Access Compliance Report

Public Rights-of-Way

(Curb Ramps)

Intersection ID: 28386	Main Street: MARVIN_RD	Cross Street: SOUTHAMPTON_COMMONS_DR	Location: E
ADA ID: D7EF017749AD	Ramp Type: Perp	Initial Pass/Fail: Fail	Overall Compliance: No
Severity Score: 10			
Codes/Mitigation Info/Possible Solution		Field Measurements/Component Compliance

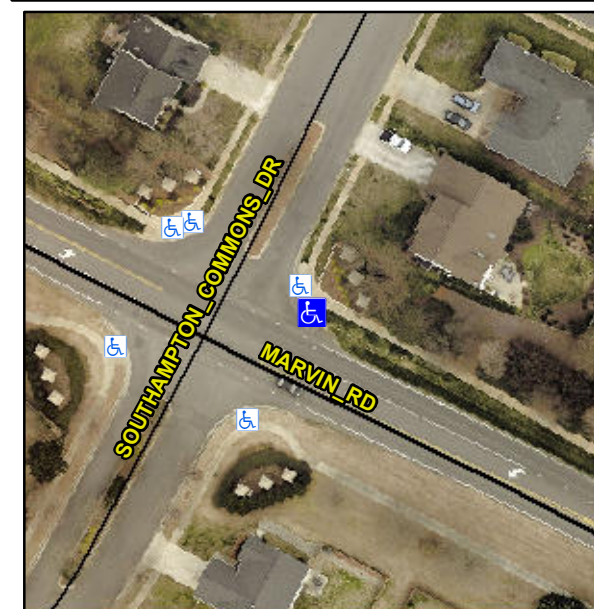
Not Found, R304.5.1, R304.5.3

Compliance	Description	Data	Compliance	Description	Data
N/A	Ramp Length (in)	69.0	Yes	Ramp Slope (%)	5.4
No	Ramp Width (in)	41.0	No	Ramp XSlope (%)	2.9
N/A	Flare Type LT	N/A	N/A	Flare Type RT	N/A
N/A	Flare Slope LT (%)	N/A	N/A	Flare Slope RT (%)	N/A
N/A	Flare Traversable LT?	N/A	N/A	Flare Traversable RT?	N/A
N/A	Landing Length (in)	N/A	N/A	DWS Provided?	N/A
N/A	Landing Width (in)	N/A	N/A	DWS Contrast?	N/A
N/A	Landing Slope (%)	N/A	N/A	DWS Length (in)	N/A
N/A	Landing X Slope (%)	N/A	N/A	DWS Full Width?	N/A
N/A	Landing Curb? (Y/N)	N/A	N/A	DWS Offset (in)	N/A
N/A	Shared Landing?	N/A			
N/A	Gutter Ponding?	N/A	N/A	Gutter Slope (%)	N/A
N/A	Gutter Lip Ht (in)	N/A	N/A	Gutter X Slope (%)	N/A
N/A	Painted X Walk1?	No	N/A	Painted X Walk2?	N/A
	X Walk 1 Direction	To SW		X Walk 2 Direction	N/A
N/A	X Walk 1 Width (in)	N/A	N/A	X Walk 2 Width (in)	N/A
	X Walk 1 Slope (%)	1.9		X Walk 2 Slope (%)	N/A
	X Walk 1 X Slope (%)	0.4		X Walk 2 X Slope (%)	N/A

Remove & Replace Entire Ramp.
